N° 10292AERRA

Errata sheet V1.10 affecting products TC39x_BC

Subject Errata sheet V1.10 affecting products TC39x_BC

Reason Update of Errata Sheet from version V1.9 to V1.10

Figure 2 Message buffer transfer from Message RAM to OBF

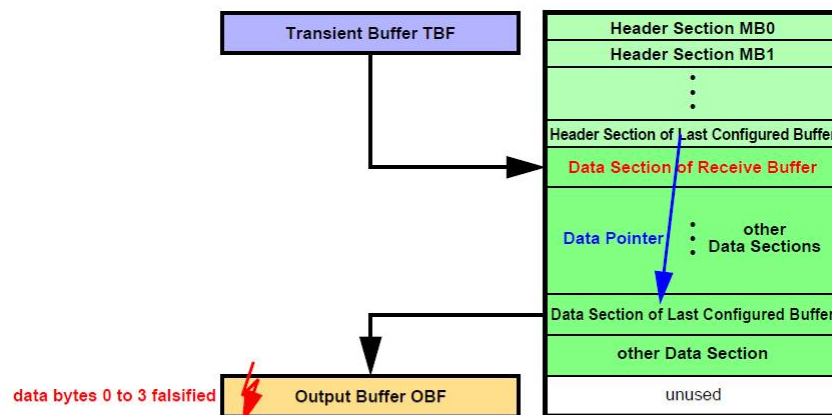
- a) Message buffer transfer from Message RAM to OBF

When the message buffer has its payload configured to maximum length (**PLC** = 127), the OBF word on address 00h (payload data bytes 0 to 3) is overwritten with unexpected data at the end of the transfer.

a) When a message is transferred from the Last Configured Buffer in the Message RAM to the OBF and **PLC** = 127 it may happen, that at the end of the transfer the OBF word on address 00h (payload data bytes 0 to 3) is overwritten with unexpected data (see [Figure 2](#)).

2) Ensure that the Data Section directly following the Header Partition is assigned to a transmit buffer.

Figure 3 Message buffer transfer from IBF to Message RAM

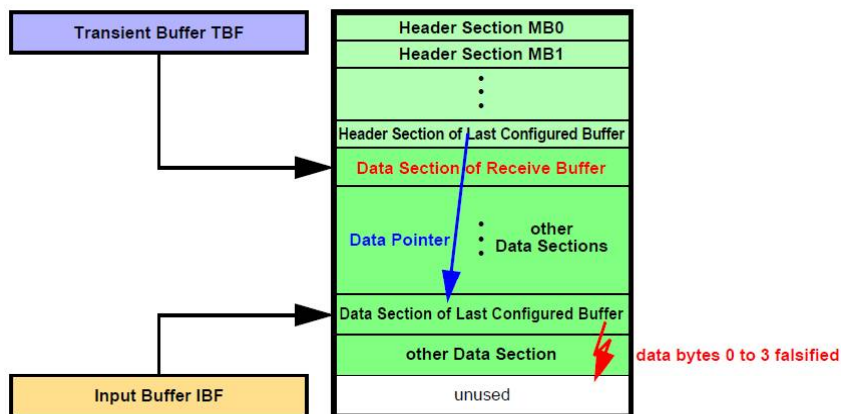
b) Message buffer transfer from IBF to Message RAM

After the Data Section of the selected message buffer in the Message RAM has been written, one additional write access overwrites the following word in the Message RAM which might be the first word of the next Data Section.

b) When a message is transferred from IBF to the Last Configured Buffer in the Message RAM, it may happen, that at the end of the transfer of the Data Section one additional write access overwrites the following word, which may be the first word of another message's Data Section in the Message RAM (see [Figure 3](#)).

Figure 4 Message RAM Configurations

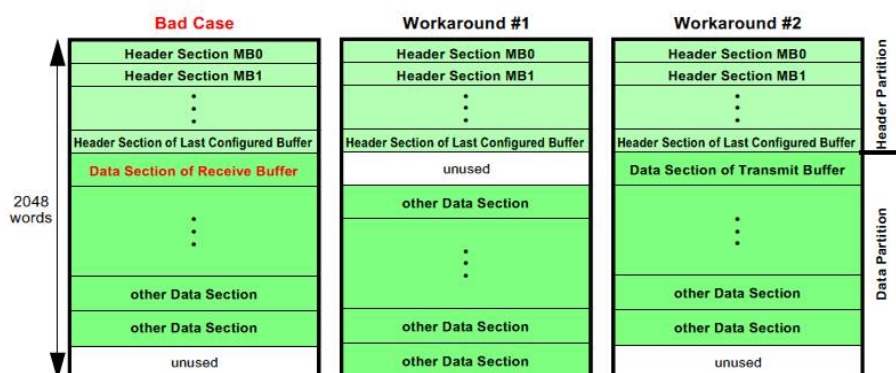
The erratum is limited to the case when (see [Figure 4](#) “Bad Case”):

Figure 7 Critical MCS AEI master scenario

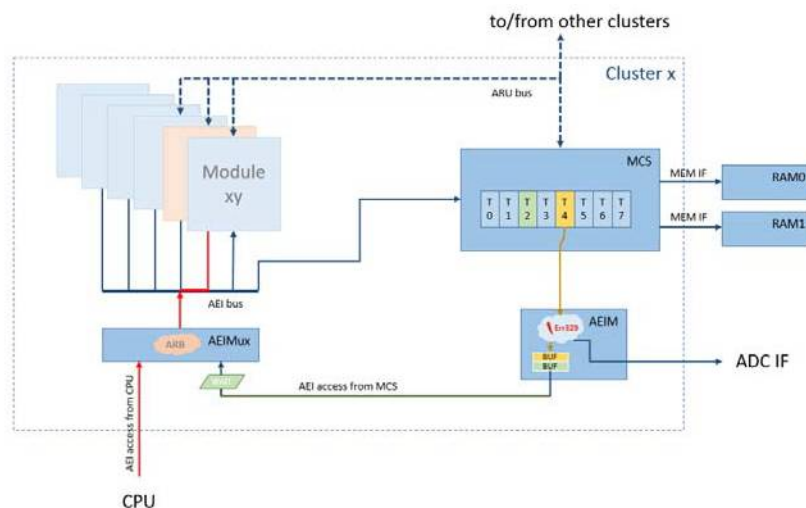
In [Figure 7](#), a potential risk for the occurrence of problem GTM_AI.329 is illustrated. Here the first buffer of the AEIM (green) is still waiting for the access to the AEI bus while a second AEI bus access from MCS arrives at the AEIM (yellow access path). Under certain, but for the user unpredictable timing conditions, this second AEI bus access arriving at the AEIM can trigger the misbehavior described in problem GTM_AI.329.

The workarounds described in the following section will ensure that not more than one AEIM buffer will be filled and therefore the occurrence of problem GTM_AI.329 is avoided. All workarounds have been tested and proven correct.

Figure 8 MCS token mechanism

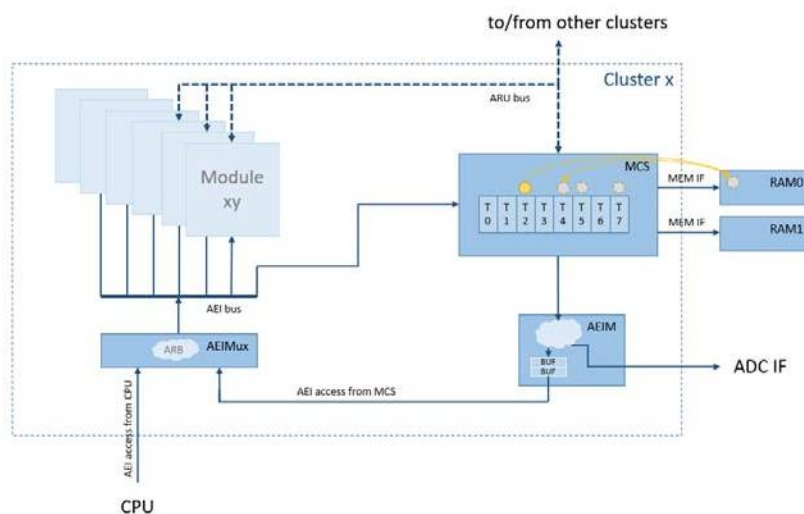
In case multiple MCS channels want to use the AEI master port for AEI or ADC communication, establish a mechanism that ensures that only one channel uses the AEI master at a time (e.g. exchange a token between channels or use trigger registers to hand over the AEI master port ownership between MCS channels).

An application note (AN020 – MCS Mutex implementation) describing a token exchange mechanism between MCS threads is available at Bosch. Such a token mechanism allows multiple MCS threads to safely access the AEI bus system by exchanging an AEI bus access token via MCS memory.

Figure 10 Interrupt Level vs. Pulse-Notify mode - Corner Case Example

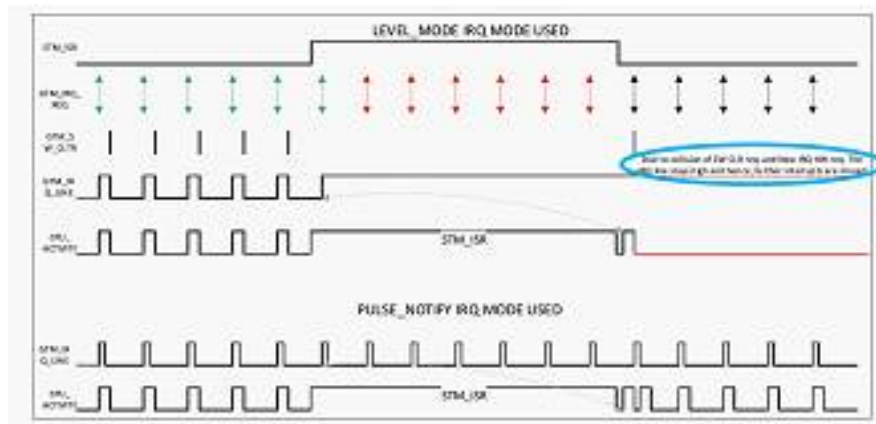
As described in the text below this figure, while using Level mode, if more internal “interrupt” events are generated (i.e. two TOM channels generating a CCU0 interrupt), just one interrupt signal is sent to the IR, and no more interrupts are triggered until the SW clears the GTM_IRQ_XXX line towards the IR.

Hence, in Level Mode, in some scenarios where another interrupt request is generated by GTM while the ISR handle also requests a SW clear, then, as the interrupt event is dominant over the clear event (for simultaneous interrupt and clear events), GTM_IRQ_XXX is not cleared and remains high. As a consequence, the IR observes no transition on GTM_IRQ_XX. Thus, any forthcoming interrupt events in this scenario are lost as there is no chance to release the CPU IRQ when a collision happens as shown in Figure below.

If Pulse-Notify mode is selected, every internal trigger will be forwarded to the IR, irrespective of the time of occurrence and the clear event, as the pulse-notify leads to set and reset of GTM_IRQ_XXX as compared to only setting of the GTM_IRQ_XXX line in Level mode.

Figure 12 Timing of LVDS TX interface command sending in relation to IRQ.IFCFS

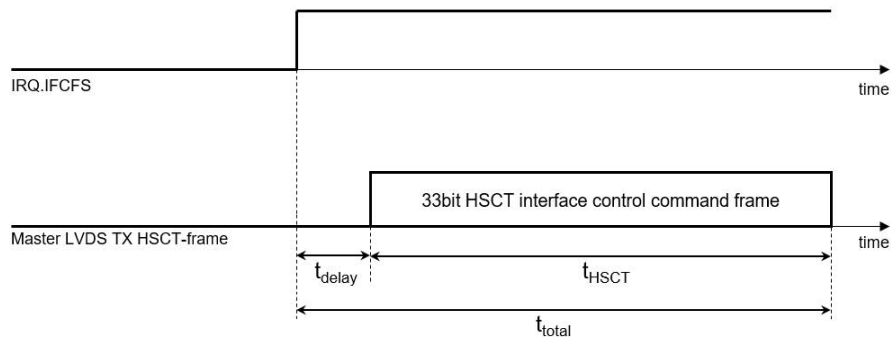
the user might falsely assume that also the actual sending on the LVDS TX port has already occurred once the IRQ.IFCFS flag is set, which is not true.

Instead the timing shown in **Figure 12** applies.

Figure 13 ADC Trigger Concept

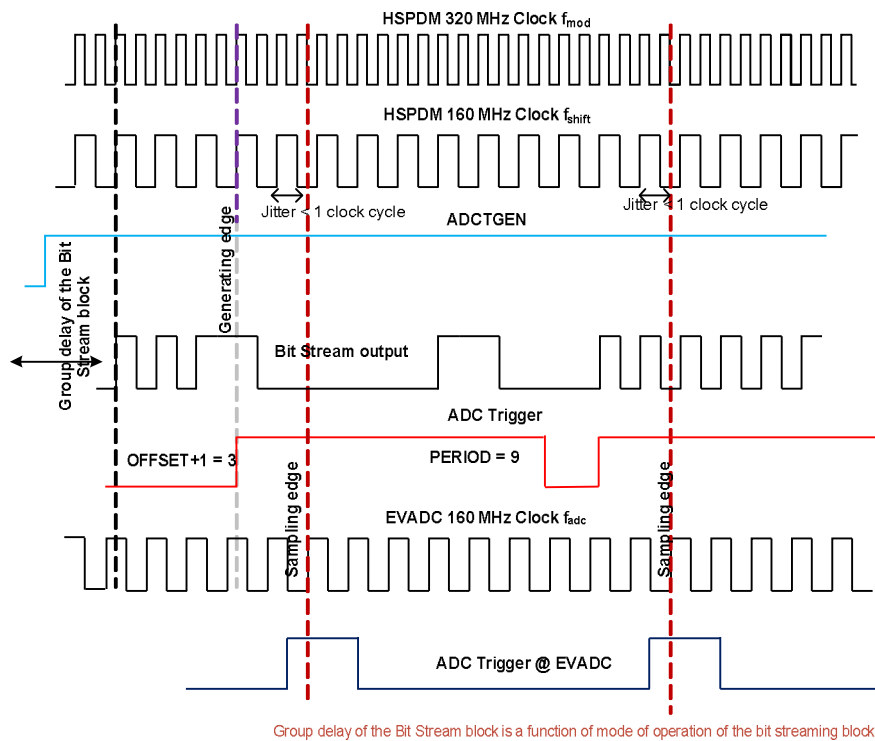
HSPDM_TC.H004 ADC Trigger Concept - Figure update

Figure “ADC Trigger Concept” in the current version of the HSPDM chapter of the TC3xx User’s Manual shall be replaced with the following updated figure:

Figure 14 SDIO Card Interrupt Sequence

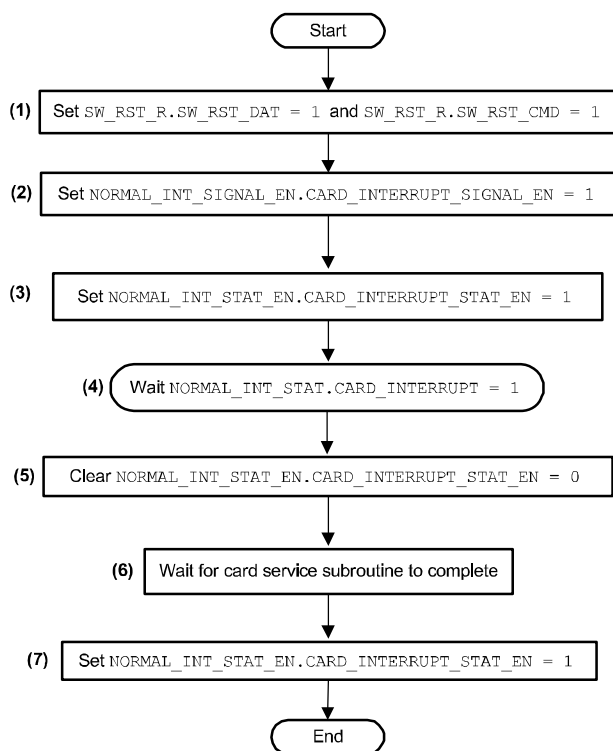
SDMMC_TC.H002 SDIO Card Interrupt Sequence - Figure update

Figure "SDIO Card Interrupt Sequence" in the SDMMC chapter of the current version of the TC3xx User's Manual is wrong. The correct sequence is shown in the following [Figure 14](#).
